CITY OF FORT COLLINS TYPE 1 ADMINISTRATIVE HEARING

FINDINGS AND DECISION

PROJECT NAME: Northern Colorado Feeders Supply – Type 1

CASE NUMBER: #PDP140010

ONTENTO SITEPLAN

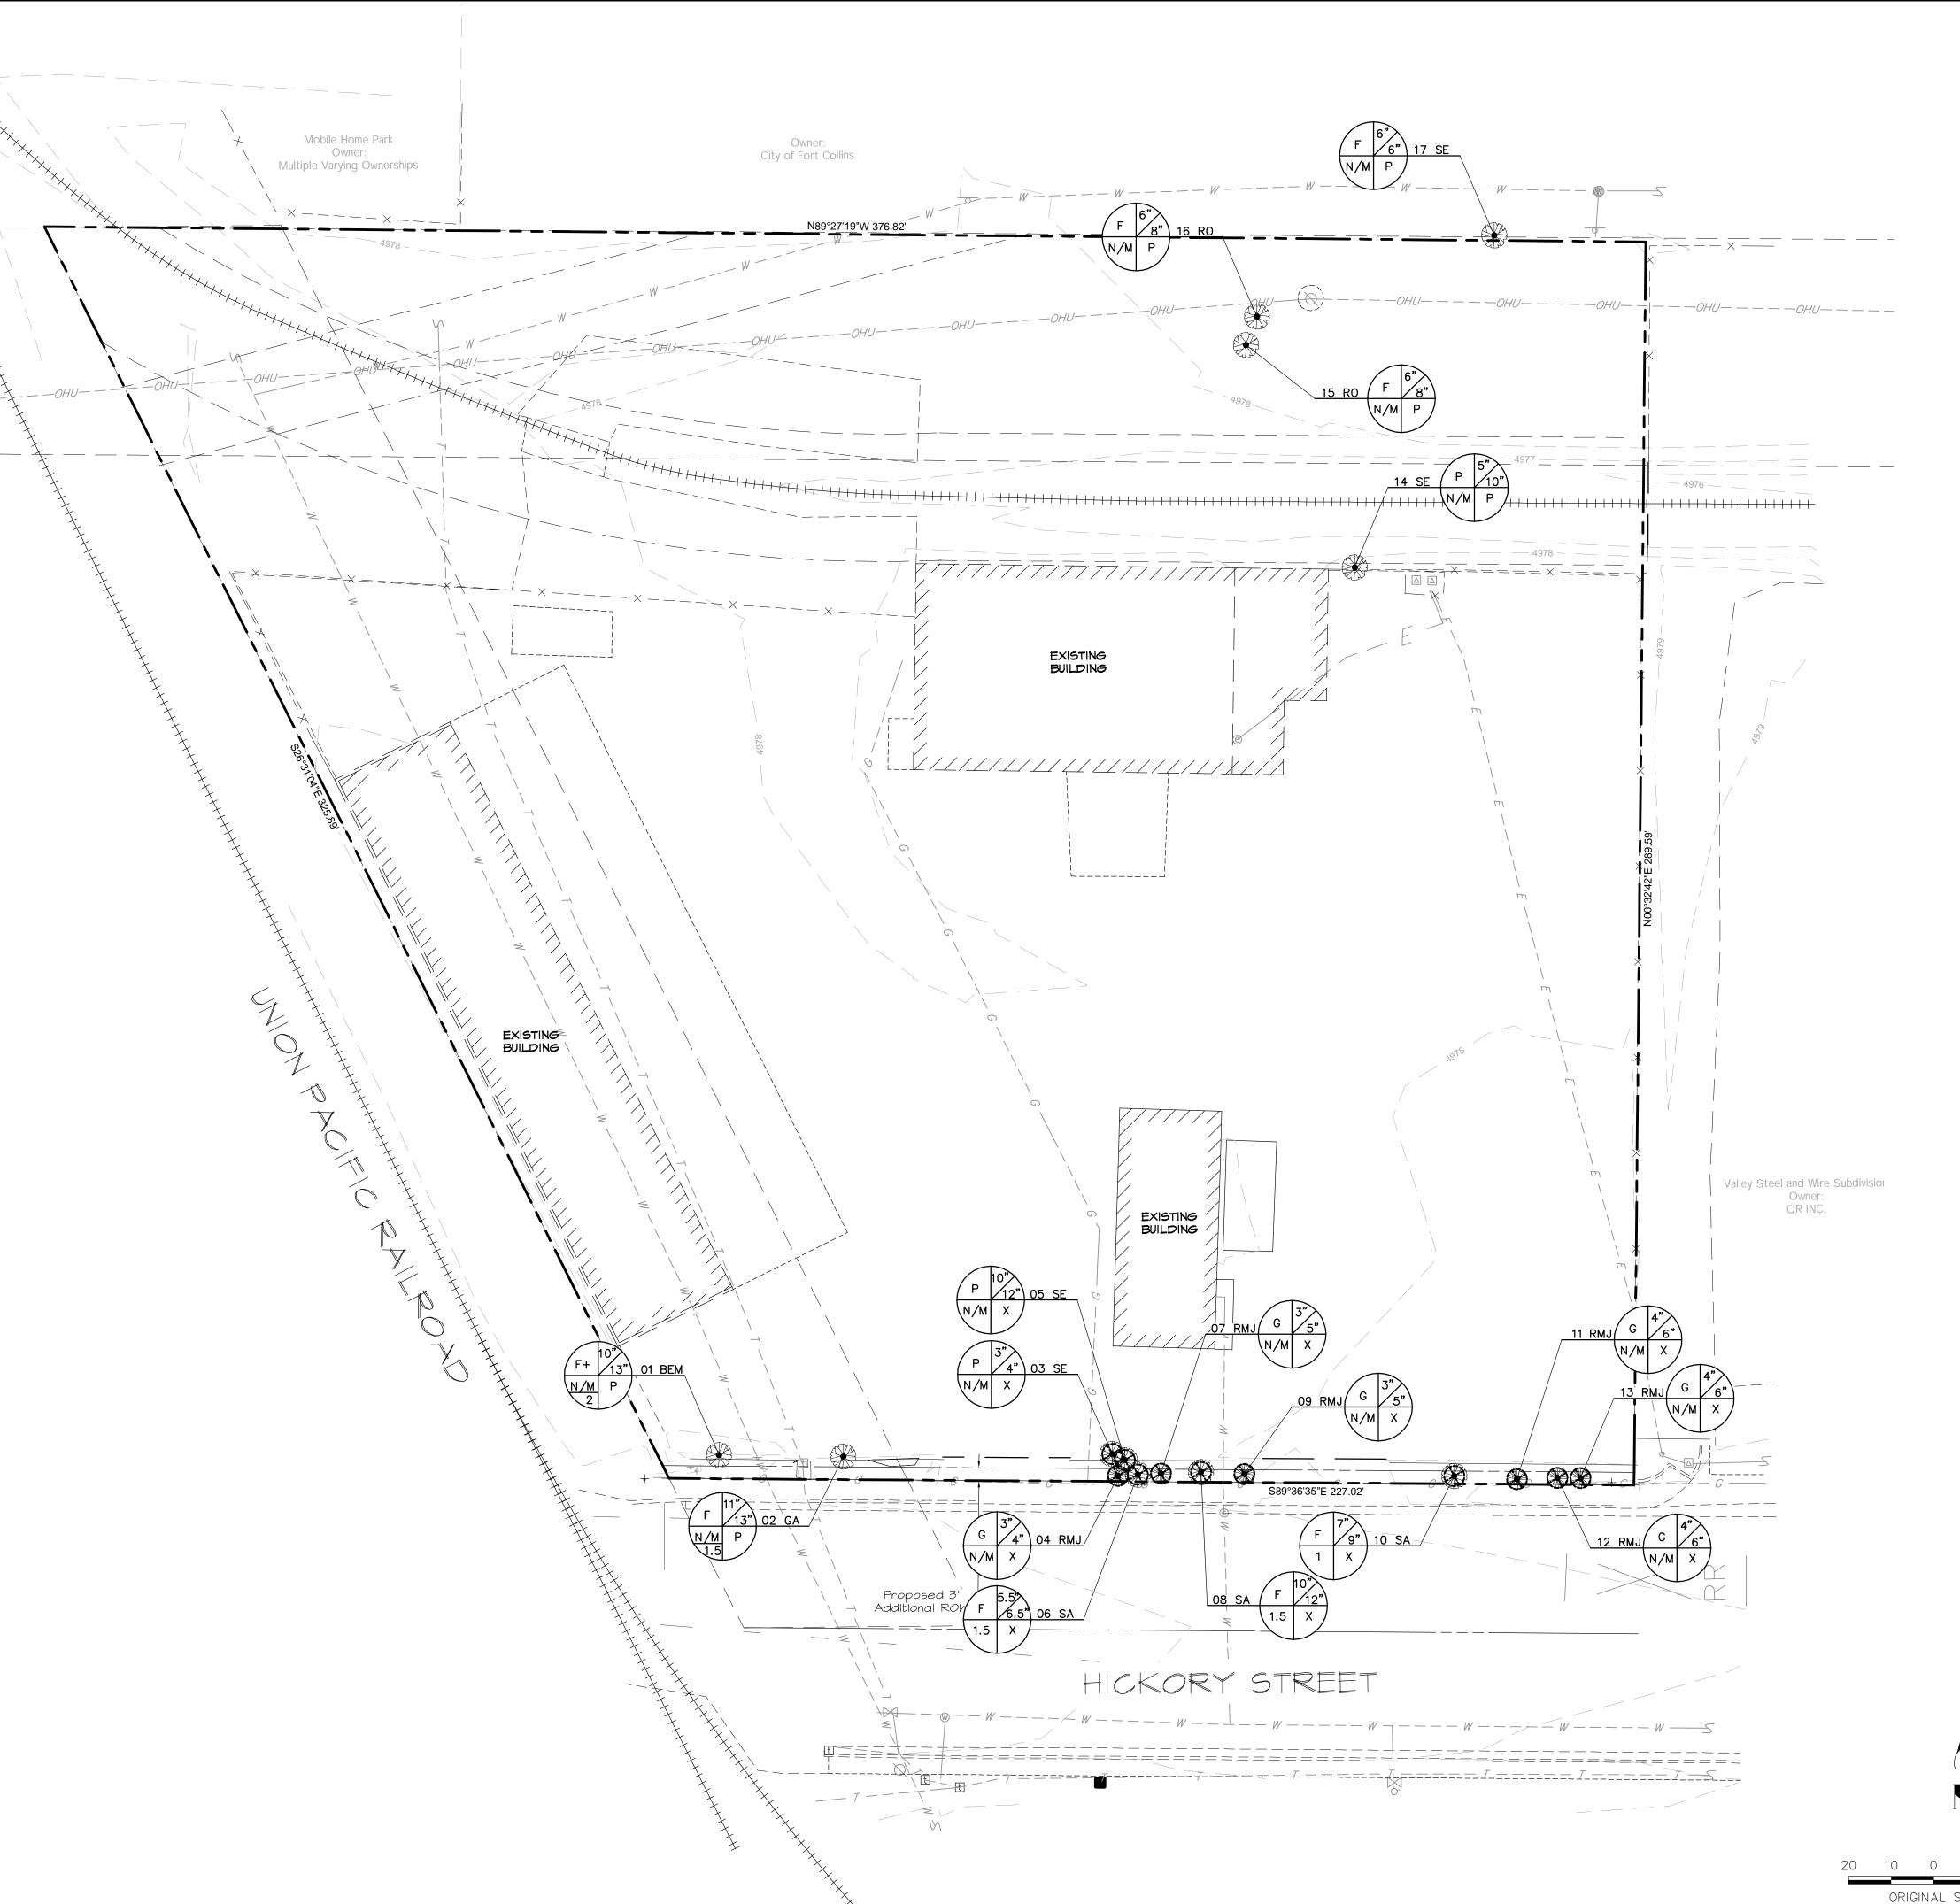
- B. The Applicant shall resolve the discrepancy in the legal descriptions currently appearing on Sheet 1 of the PDP and the Plat to the satisfaction of City Staff. The land area of the Subject Property (in acres and square feet) shall match on the final plan and Plat.

- C. NCFS shall dedicate an emergency access easement to the Poudre Fire Authority sufficient to allow the Authority unobstructed access to reach all buildings located on the Subject Property. NCFS shall also incorporate any other striping and/or signage requirements, as may be requested by the Authority or City Staff, into the final plan. The dimensions and location of the emergency access easement shall clearly be shown on the final plan and Plat.

The project complies with all setbacks for vehicle use areas along a nonarterial street and along lot lines, with the exception of a required 5' setback for a vehicle use area along the western lot line. The applicant has requested a modification to this standard to reduce the landscaped setback to 0' from the required 5' on the grounds the modification does not diverge from the standard except in a nominal, inconsequential way when considered from the perspective of the entire development plan.

STING TREE , MITIGATION N. S. SHEET **1** OF **3**

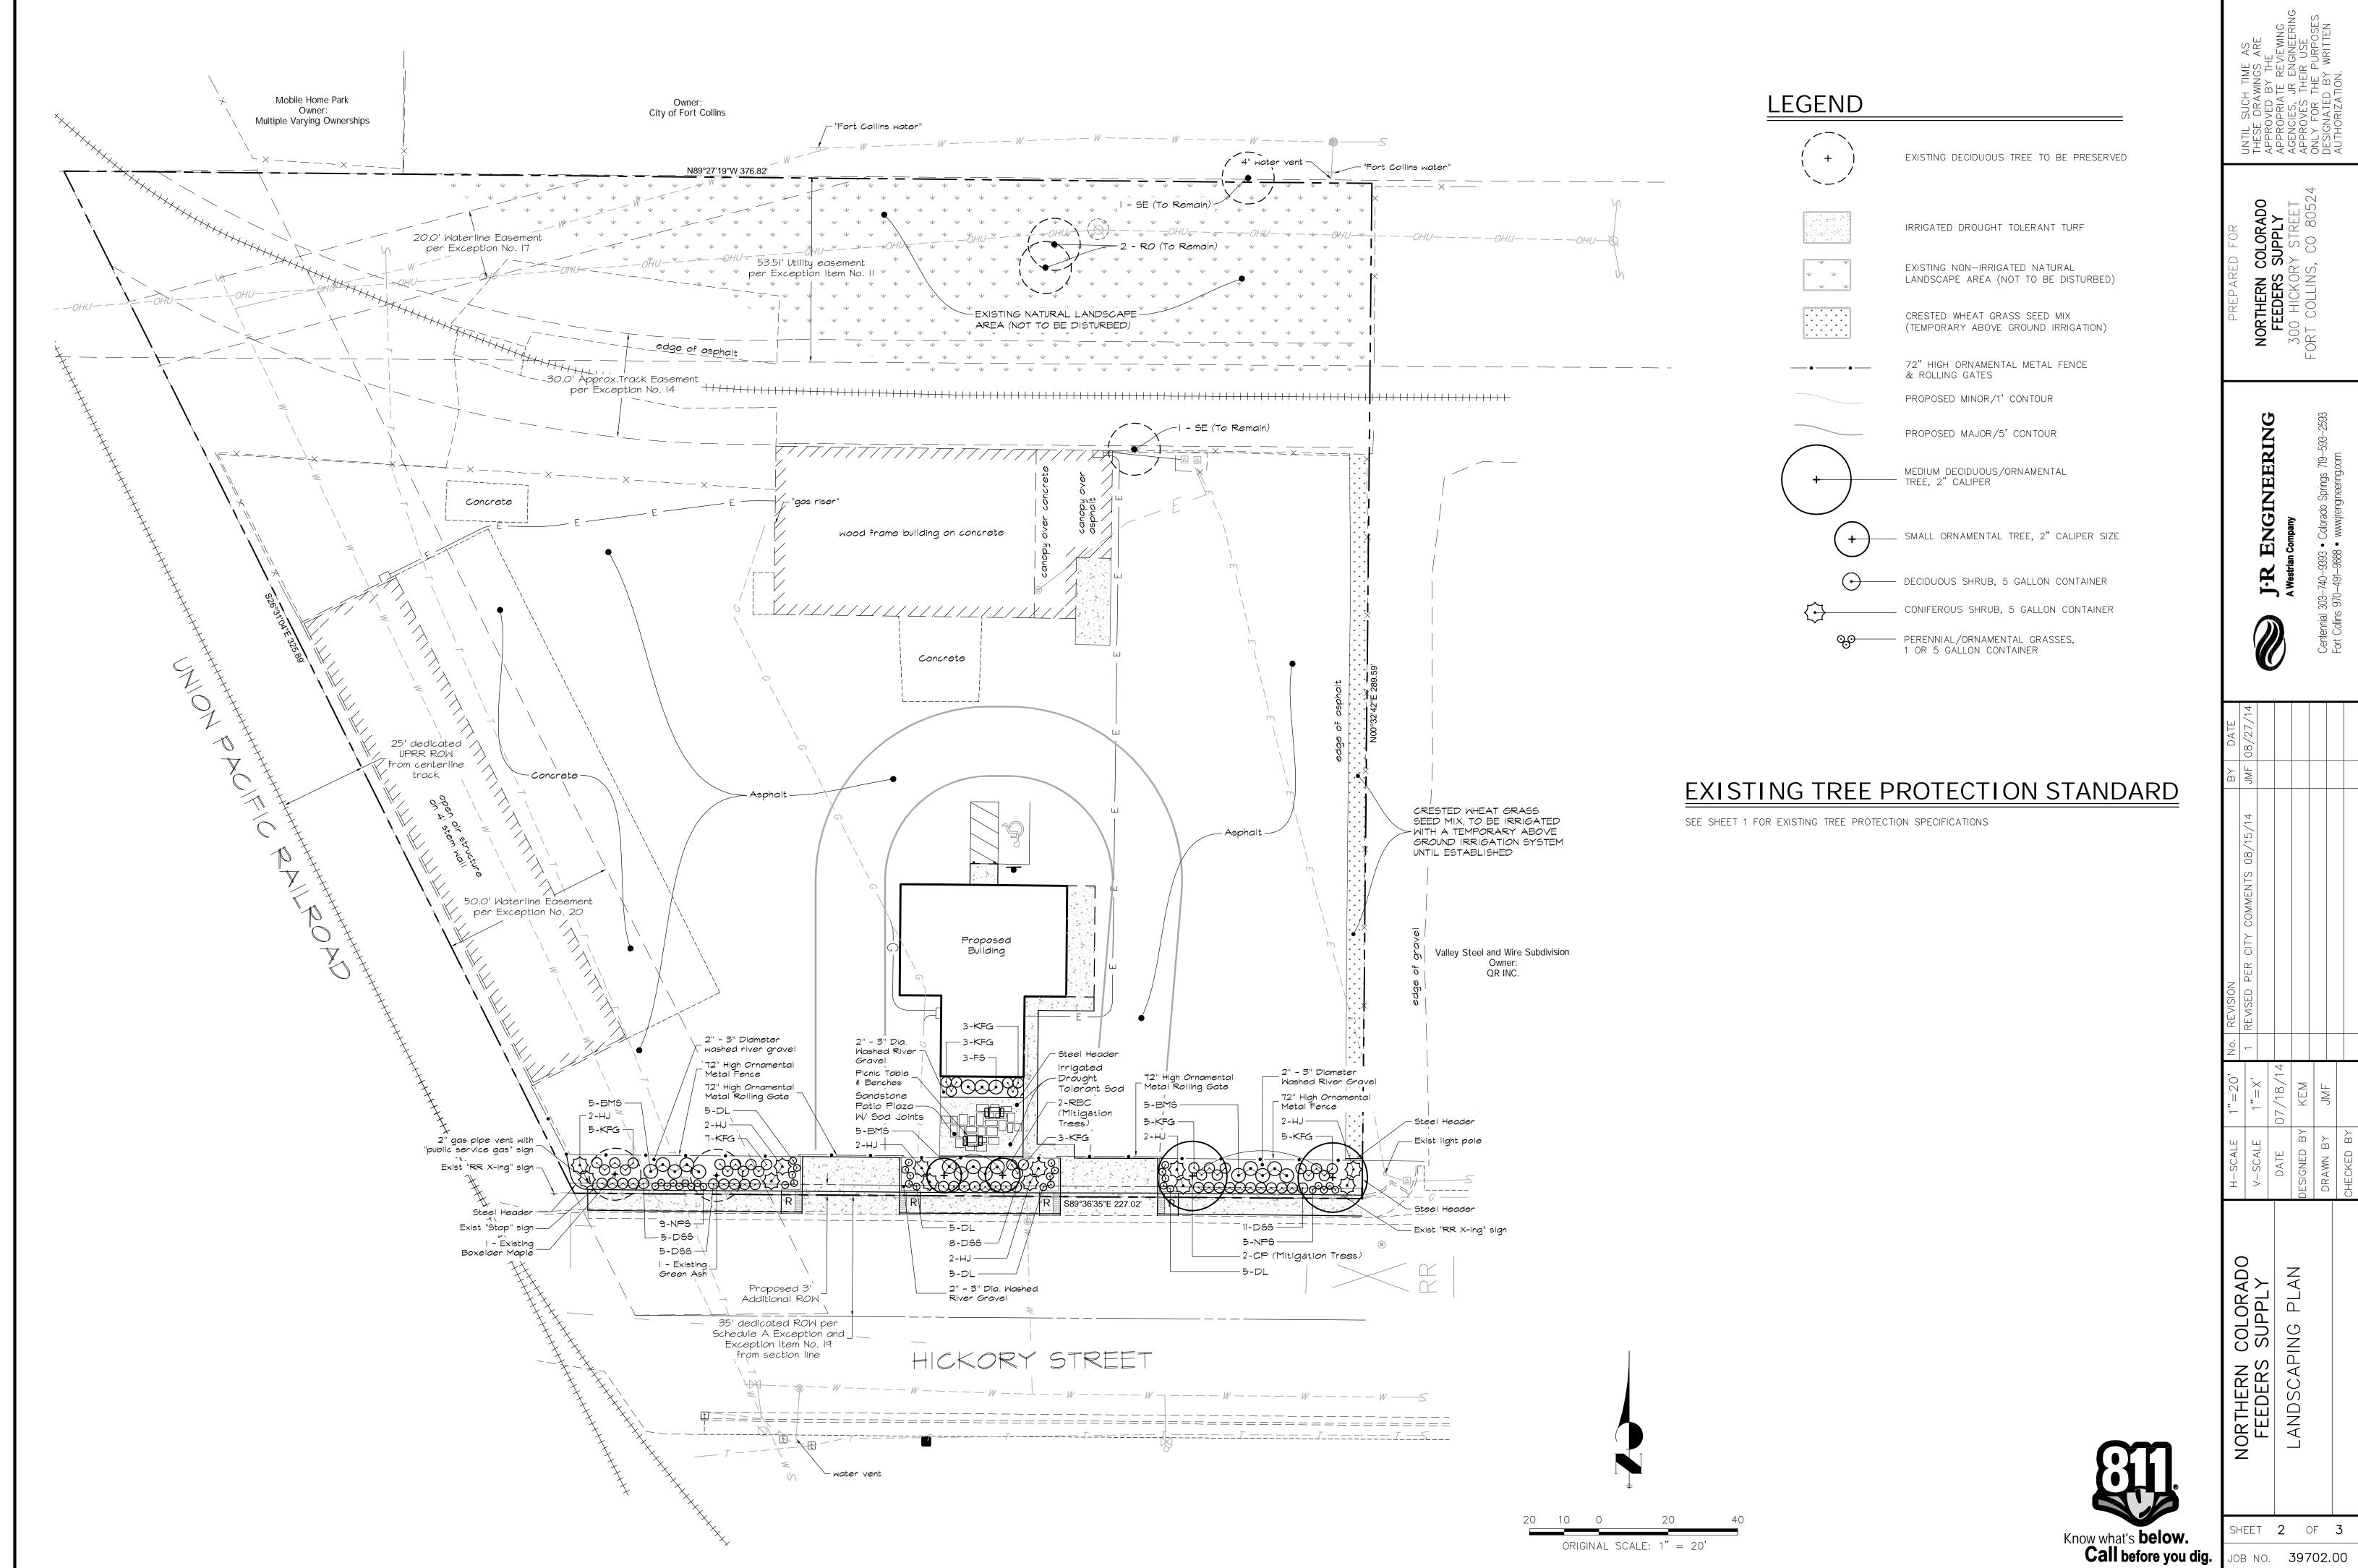
The applicant has submitted an alternative compliance request and landscaping plan that would establish the required 5' landscaped setback along the properties eastern lot line by removing a strip of

existing asphalt; however, the landscaping would consist predominately of a native grass seed mix, and would not contain trees planted at 40' intervals. In addition, the request would not landscape 6% of the interior of the parking/vehicle use area (considered all areas of existing paving) with elements such as raised landscape islands. Instead, the alternative compliance request and proposed landscape plan would focus landscaping typically reserved for these areas towards the front of the property along the Hickory Street right-of-way.

Staff has reviewed the alternative compliance request and proposed landscape plan and determined the alternative compliance request accomplishes this section equally well or better than would a plan which complies with the standards of this section based on the following elements and analysis:
